## Appendix F: Survey Results & Other Feedback

# Augustine Cut Off Multimodal Improvement Study Phase 2

## Augustine Cut Off Phase 2 Corridor Study

# Augustine Cut Off: Cantera to Edgewood

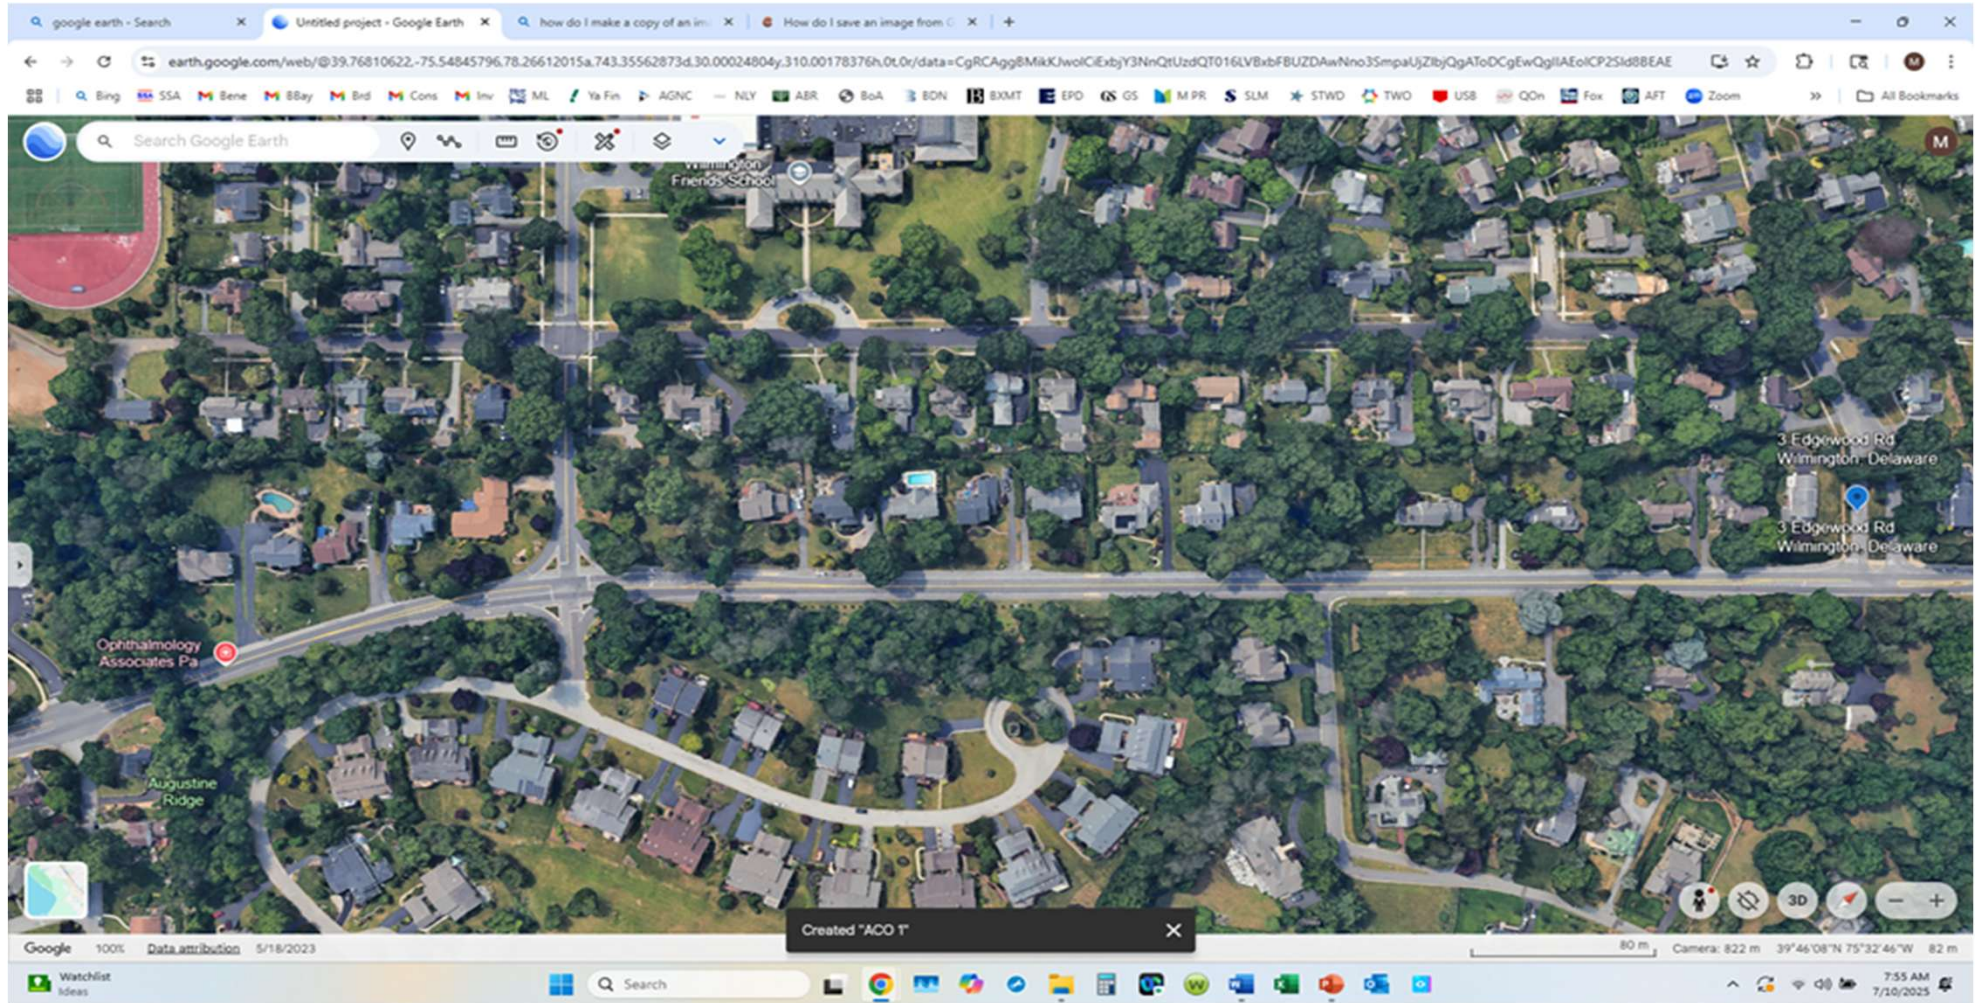
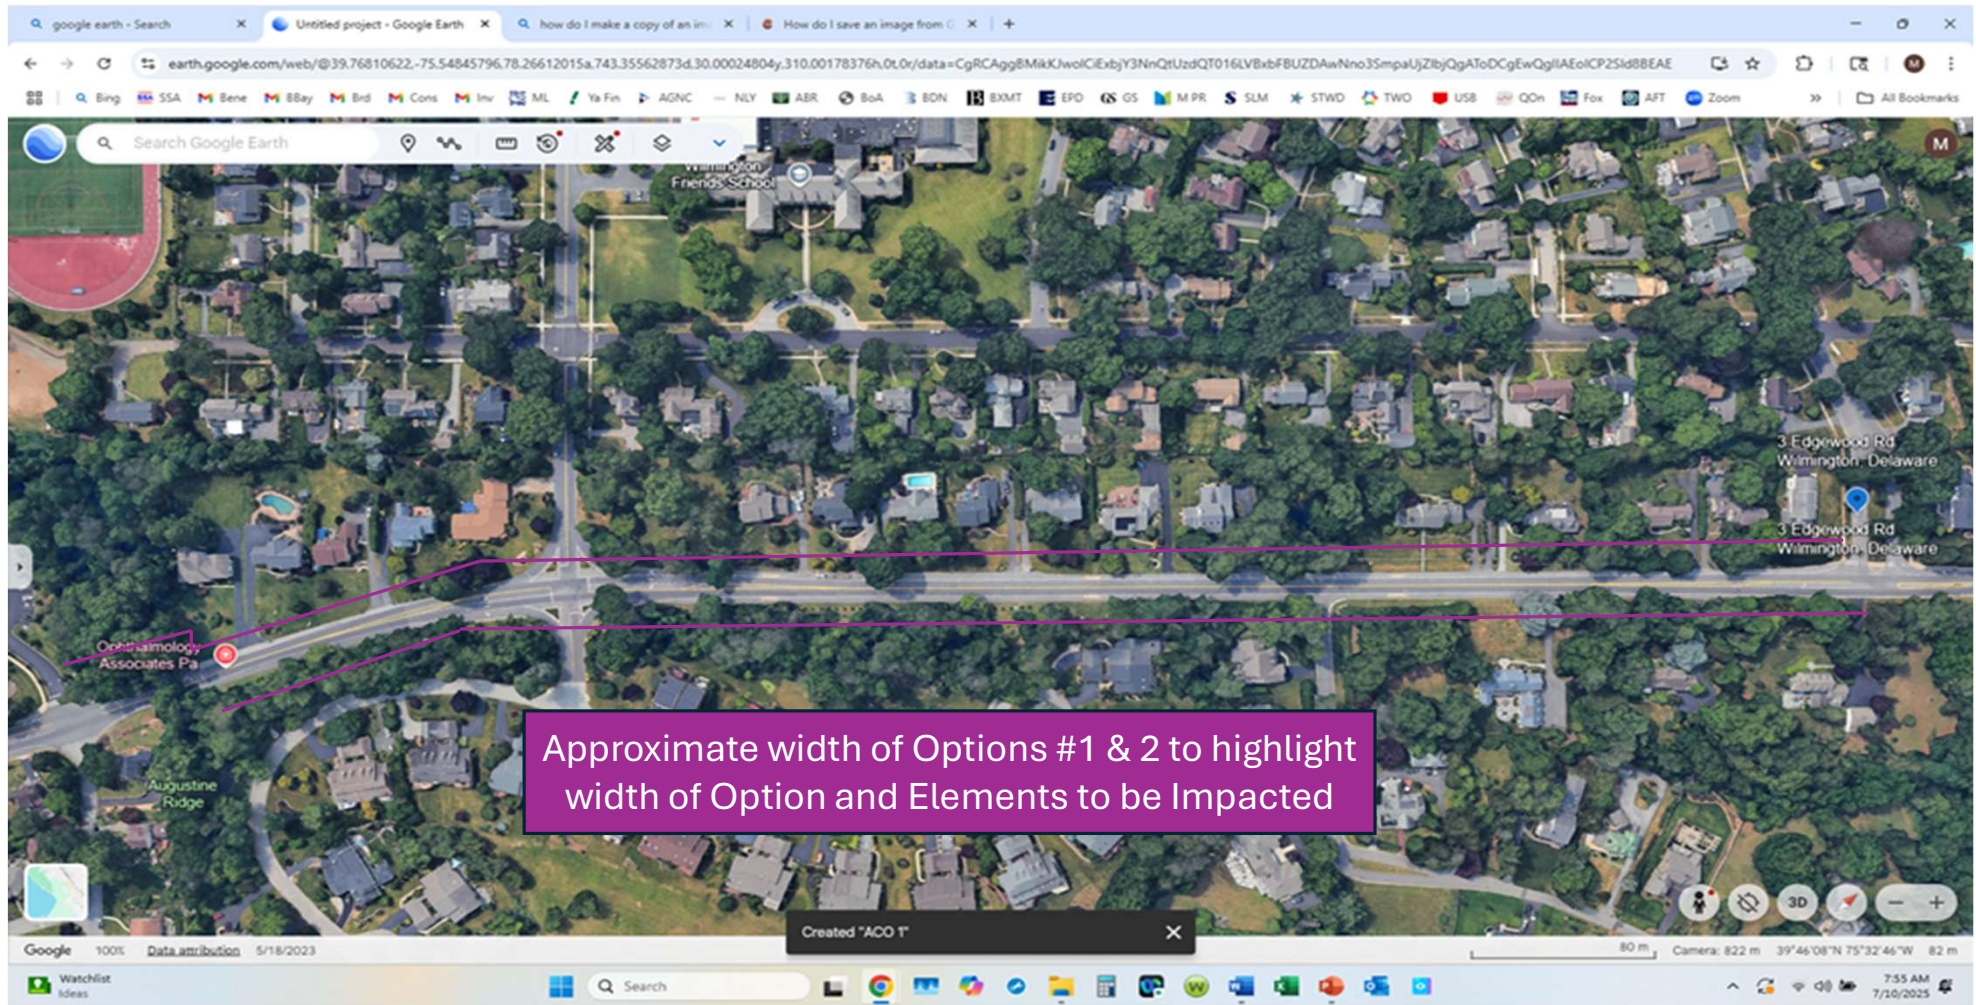
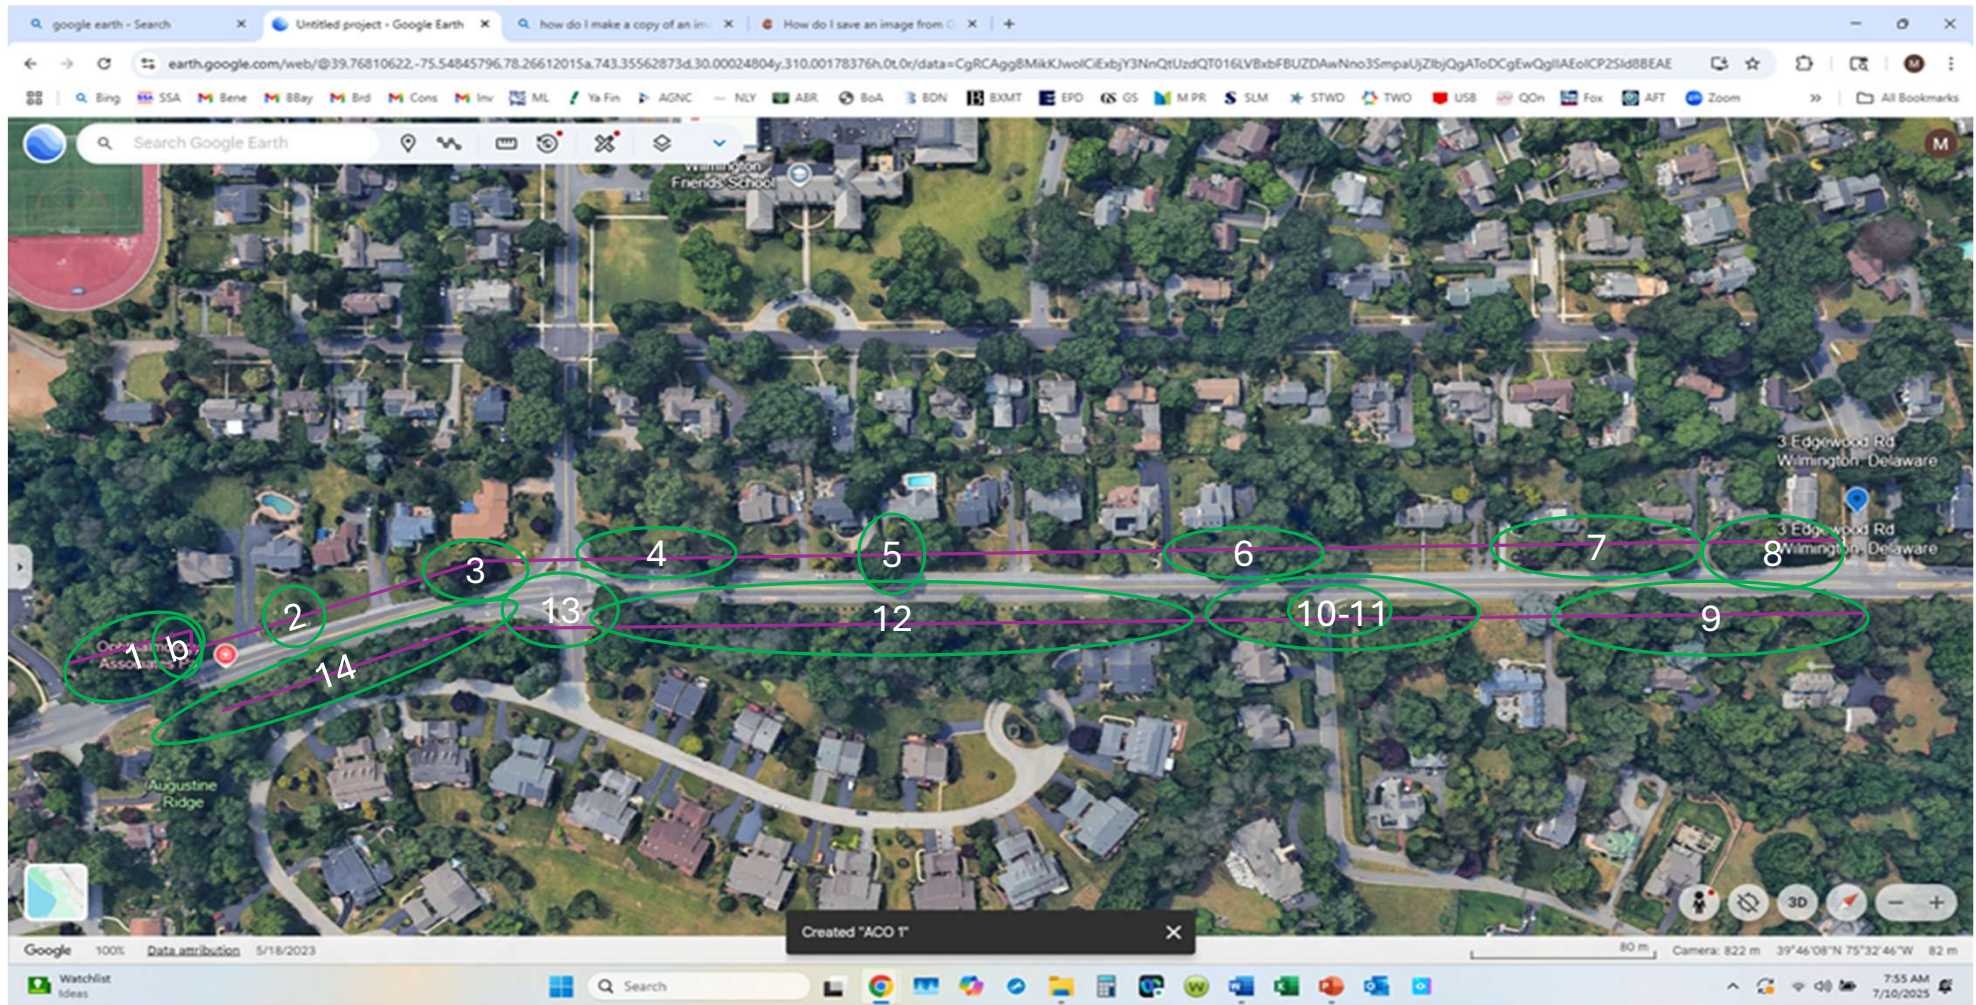
1. B) Represents a 60-80 year old cherry tree which appears to have been planted at the corner of the old Wanamaker property, where it met the old Scott Paper (?) property, to note property corners. Was mature when I first saw it 39 years ago.
2. Developed, mature bed with tree at 137 ACO
3. Group of trees at 133 and 131 ACO, including a ca. 80-year-old Dawn Redwood and a group of trees shielding 133 from the road, traffic and noise. The Dawn Redwood was mature when I first saw it 39 years ago.

Much of Rock Manor was built in the late 30s or early to mid-40s, inferred from NCC Parcel Search data. It can also be reasonably inferred that much of the landscaping associated with these residences (primarily the trees) were planted at approximately the time that the homes were built and sold.
